# **Byron Unit 1 Extended Cycle 8 Report**

**ComEd**

**October 1996**

### **BYRON UNIT 1 RESPONSE TO**

**Figure 19. Voltage Normalization Regression Analysis,  
0.080 and 0.115 inch Coils, Maximum and Average Voltage**

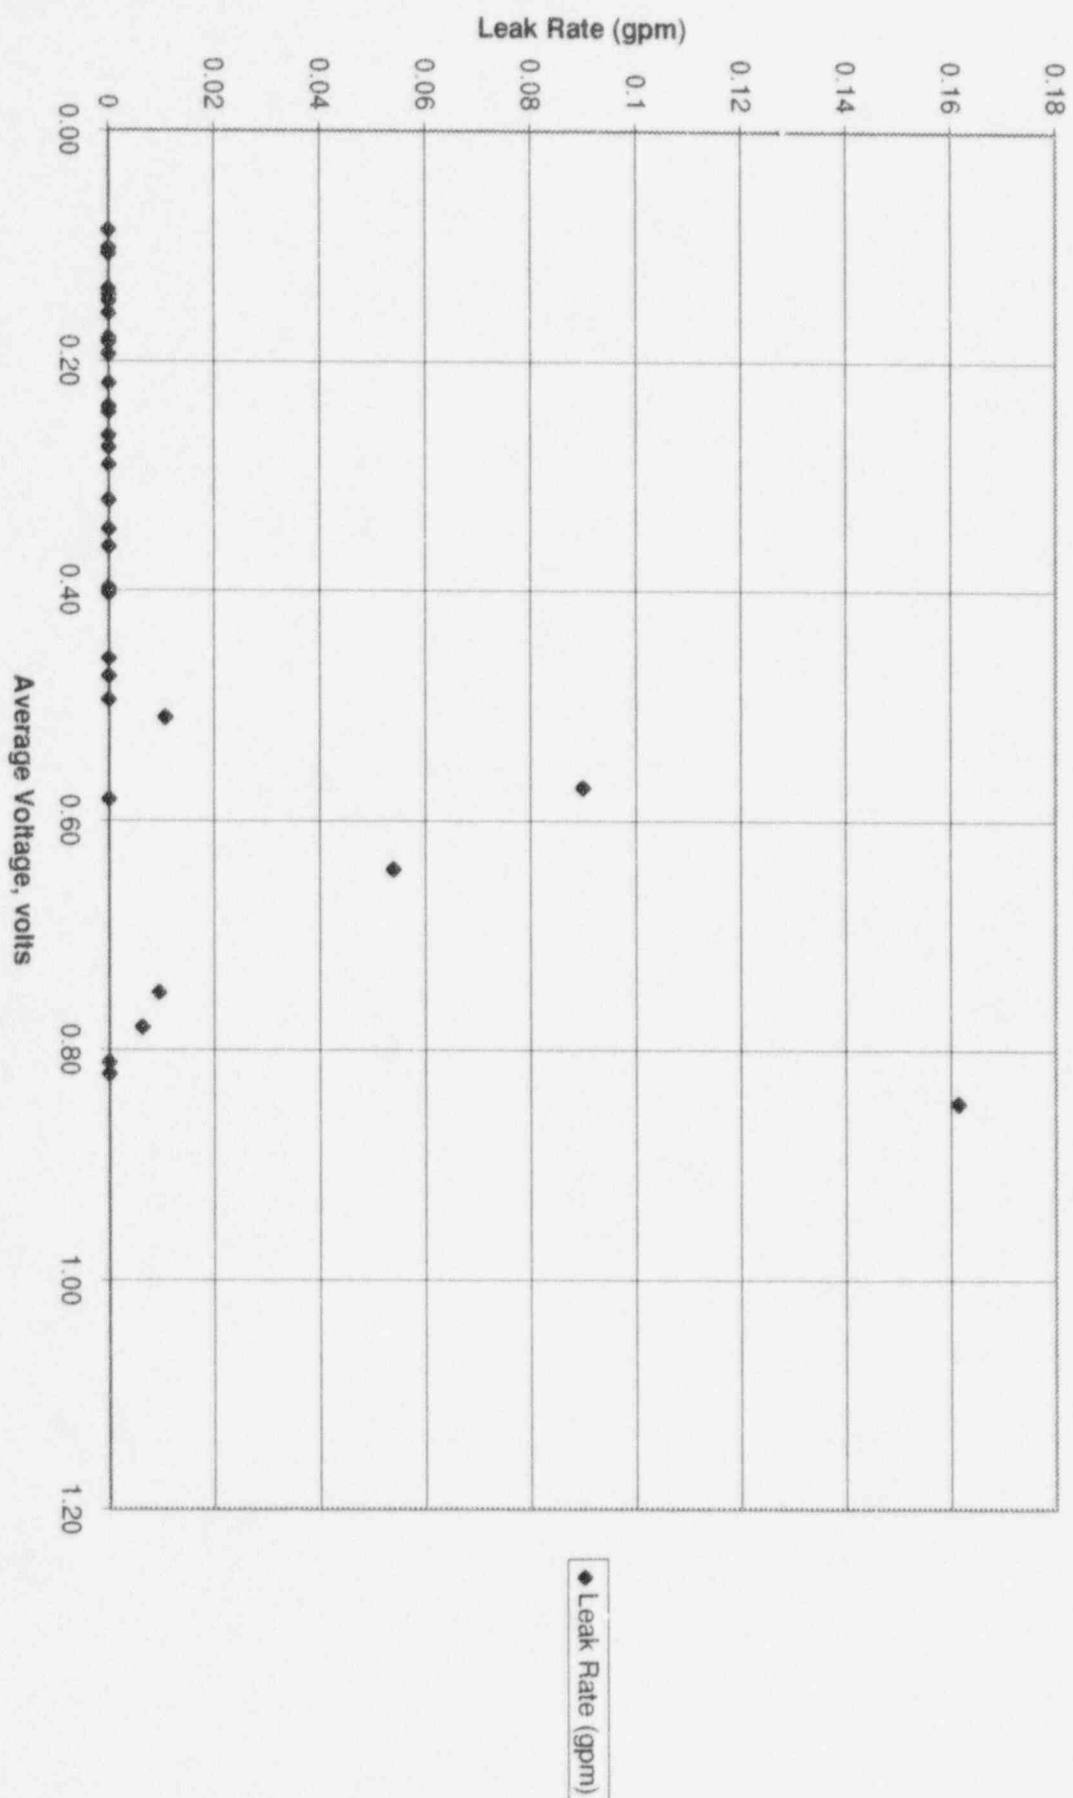
19. In Section 6.2.1 of the submittal dated August 2, 1996 the EC voltage normalization procedure for adjusting the SG tube burst and leakage data is described. This EC voltage adjustment was made to obtain consistent EC voltages for circumferential indications where the calibration standard did not contain an axial EDM notch. Discuss how the EC voltages for other reflectors in the calibration standard compare with the 0.58 correction factor applied to the data. Provide a statistical analysis based on field data which supports the use of the 0.58 correction factor.

Normalization correction factors are provided for the 0.115" and 0.080" pancake coils for assessment of industry tube pull and insitu pressure test ECT data. Further discussion of this topic is provided in response to October 3, 1996 RAI Question 2 and 3.

**Figure 20. Correlation of 20 Volt to 10 Volt Normalization Data,  
0.115 Inch/20V Coll Data Adjustified by 0.75 Factor, Average & Maximum Voltage**

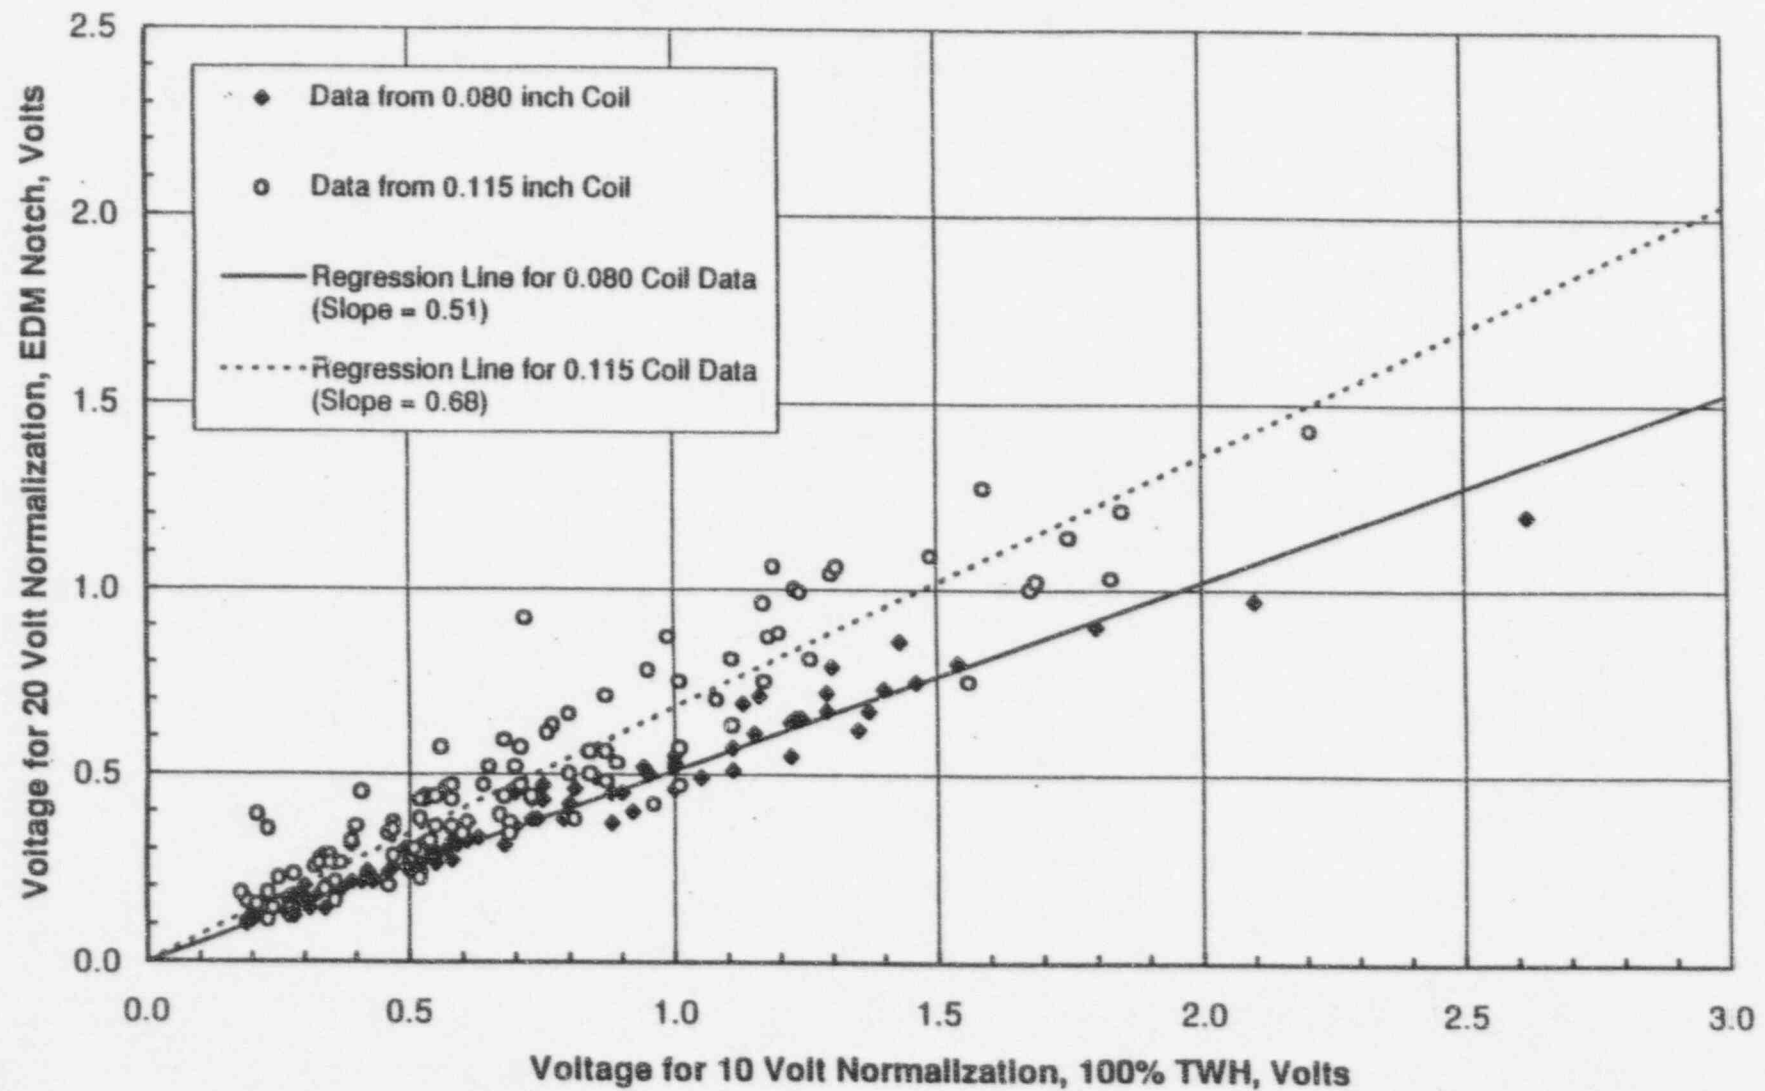
20. A 0.76 correction factor was applied to adjust 0.115-inch probe coil EC voltages to equivalent 0.080-inch probe coil EC voltages. Describe in detail the development of this correction factor, including a discussion on the number of samples reviewed, the types of defects analyzed, and the mean and standard deviation of the study sample. Additionally, provide the recorded EC voltages, if practical, or the range of circumferential indication EC voltages included in the sample. Provide a statistical analysis based on field data which supports the use of the 0.76 correction factor.

Further discussion of this topic is provided in response to October 3, 1996 RAI Question 2 and 3.

Figure 26a: Distribution of Average Volts Percent Error

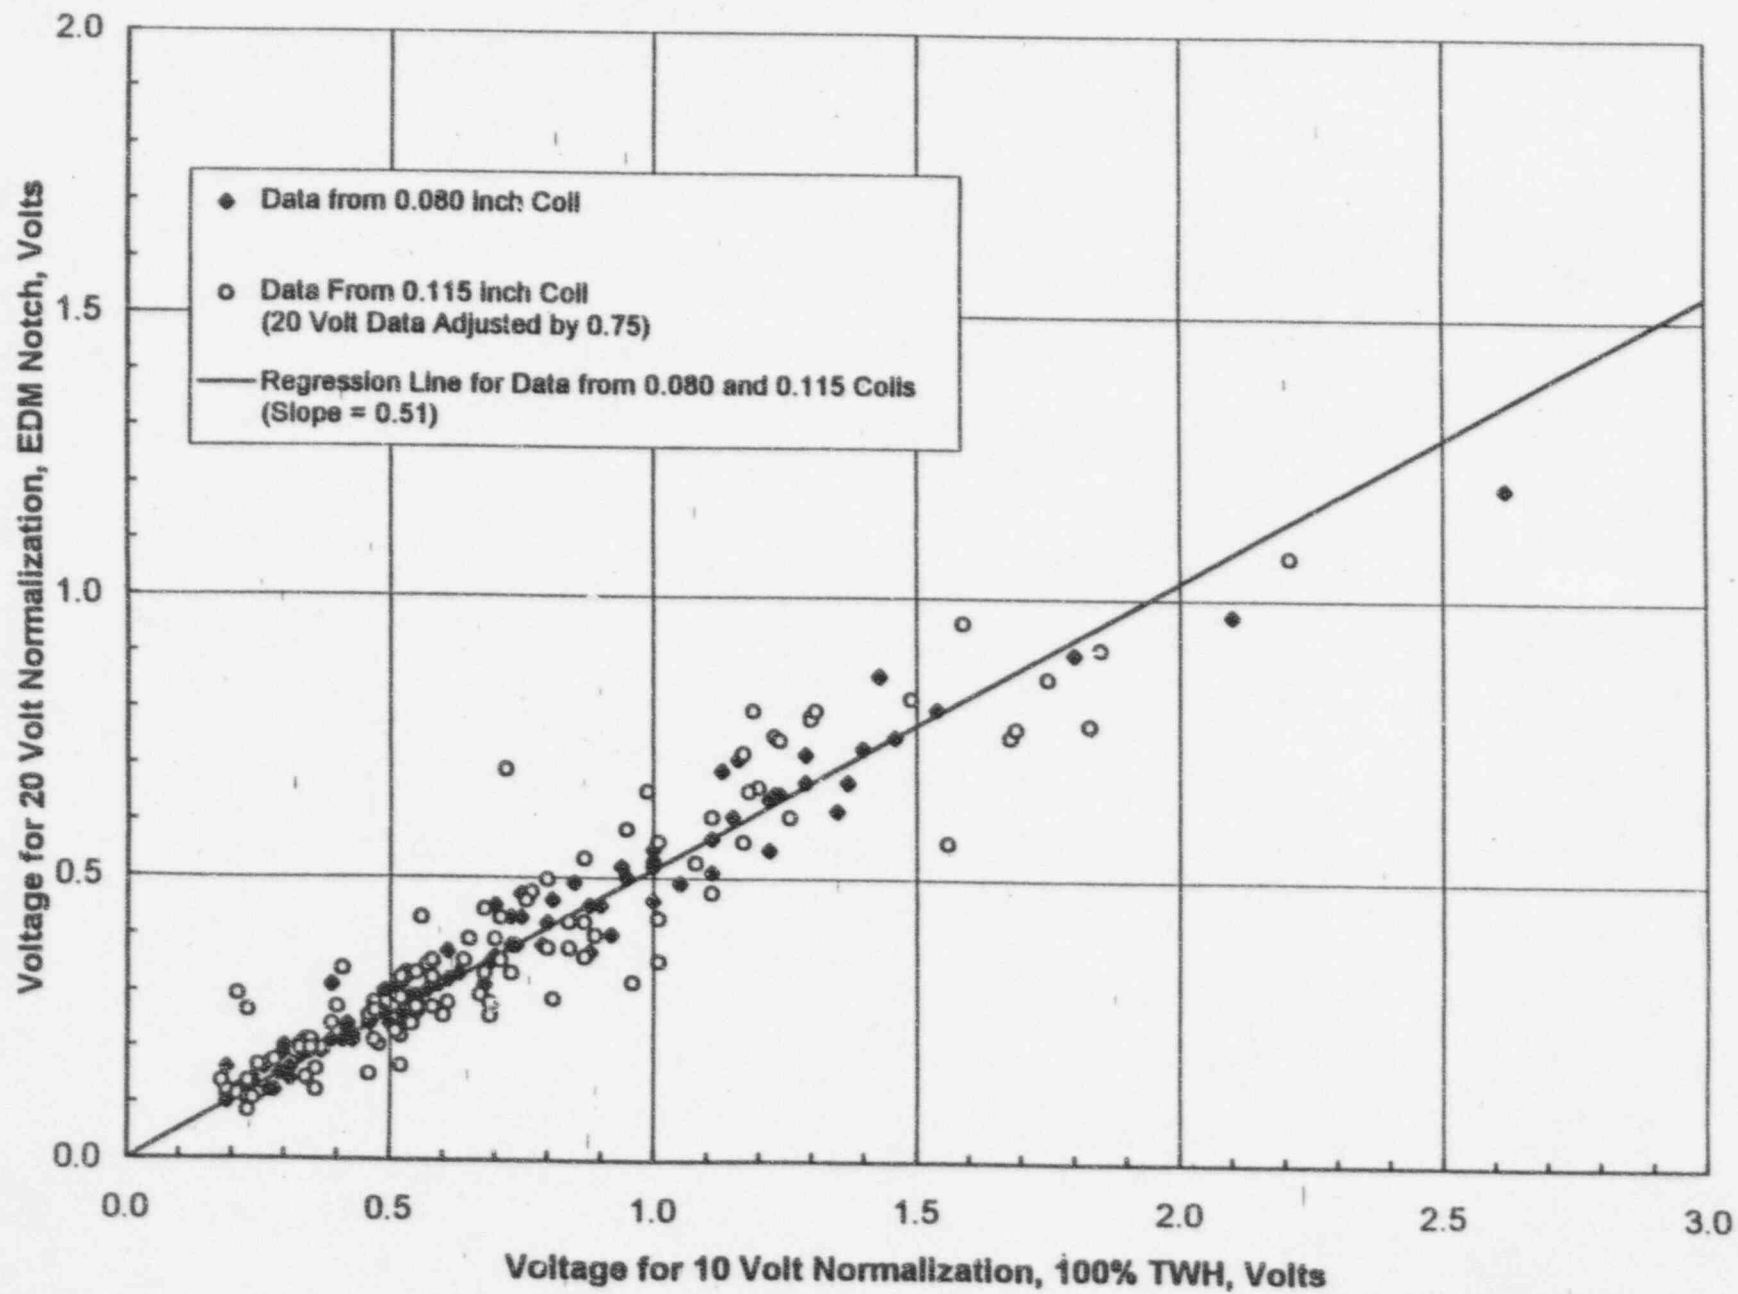
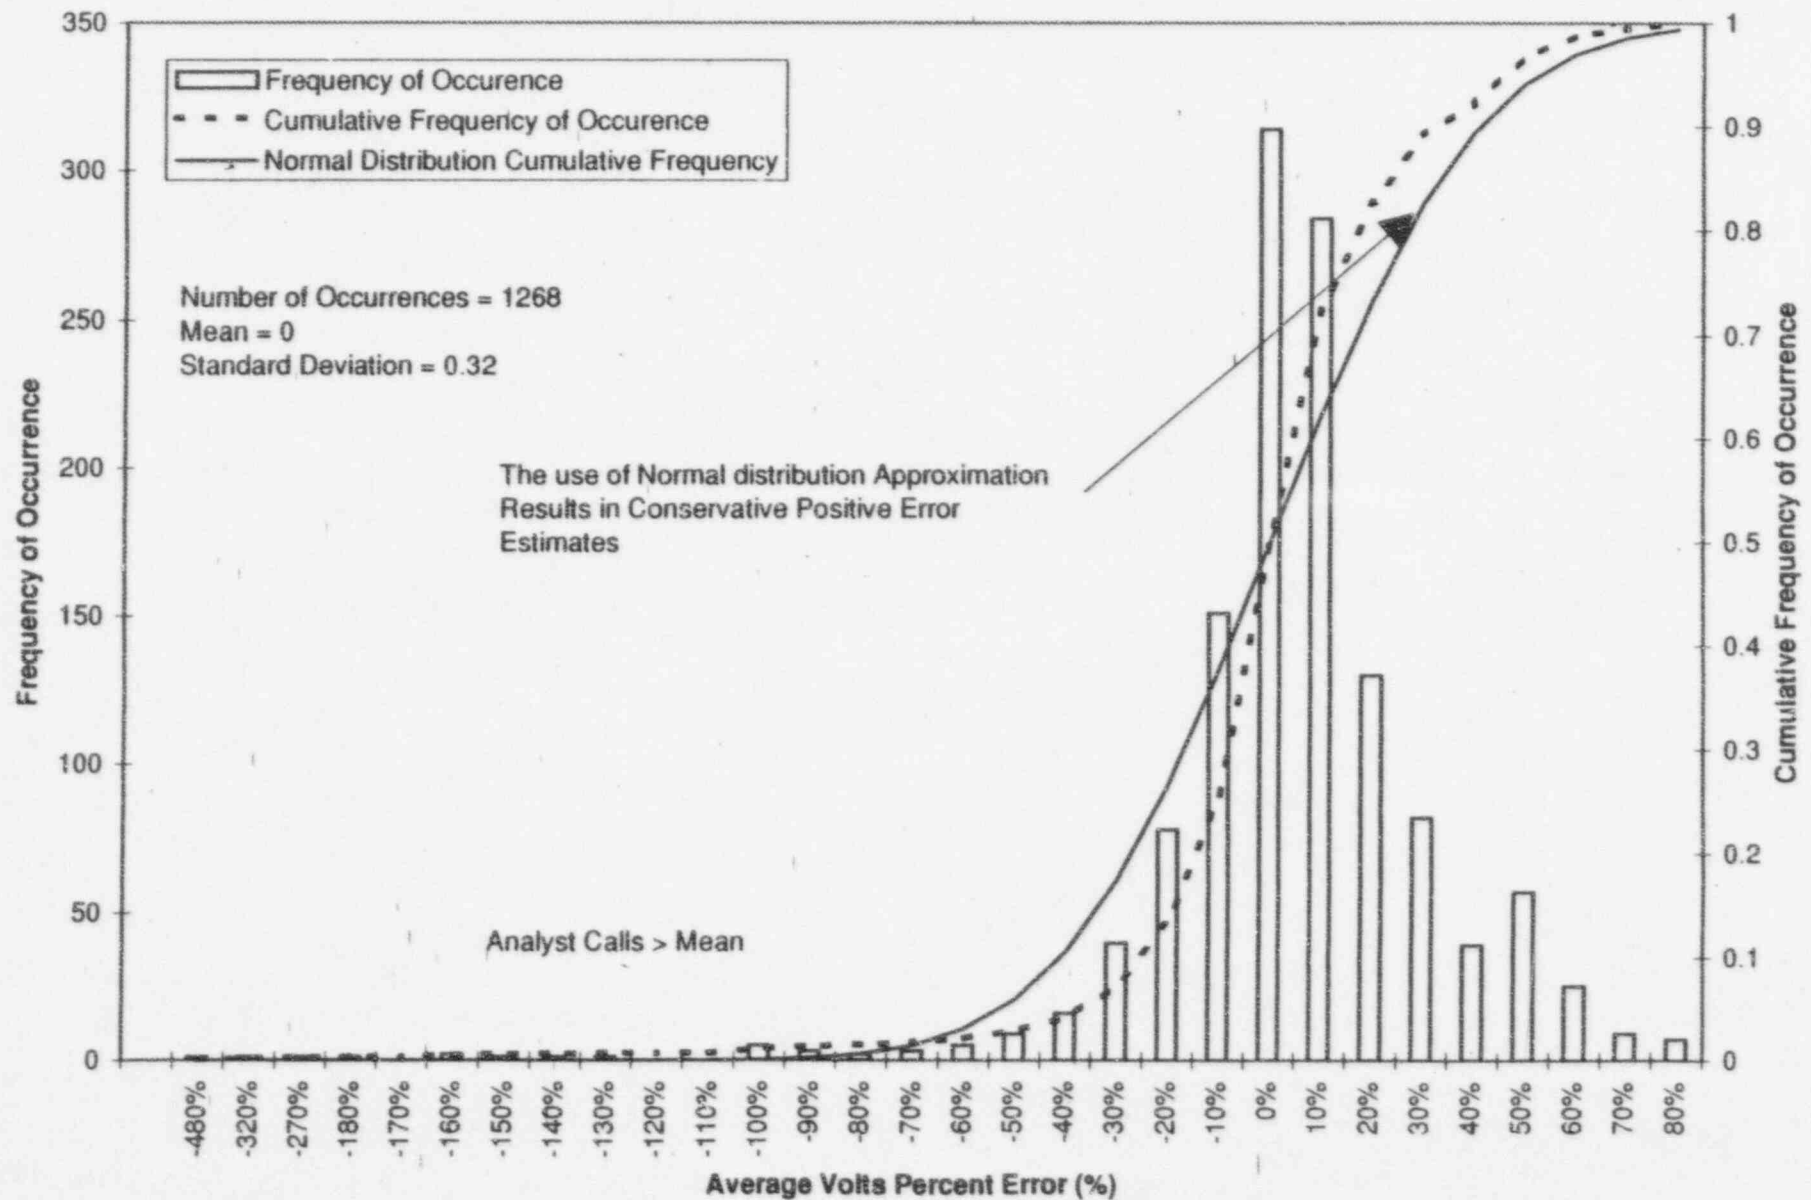
- 2.5. **Discuss the basis for keeping the data from the 100 SG tube and 200 SG tube tests separate for the analyst variability study. Provide and discuss the mean, standard deviation, and shape of the distribution used for the model of analyst uncertainty (e.g., a normal distribution with a mean of x and standard deviation of y). Discuss the technical basis for the distribution which was used.**

The additional blind test was comprised of a single population of tubes (141) with a single result for average and maximum voltage being determined. The results of this blind test will be used for end-of-cycle analyses which are based upon results from look-backs. The distribution of percent analyst error is assumed to be normal with a mean of zero and a standard deviation of 32% and 30% for average and maximum volts, respectively. Figure

26a and 26b show the distribution of analyst deviation for average and maximum voltages, respectively including the cumulative frequency distribution for the percent analyst error and the cumulative normal distribution. The cumulative frequency distribution of percent analyst error closely approximates the cumulative normal distribution particularly at the high end tail of the distribution. The percent analyst error distribution is more peaked than a normal distribution; therefore, would predict higher analyst uncertainty just above the mean than assuming a normal distribution. A normal distribution for percent analyst error provides conservative results for larger uncertainties.
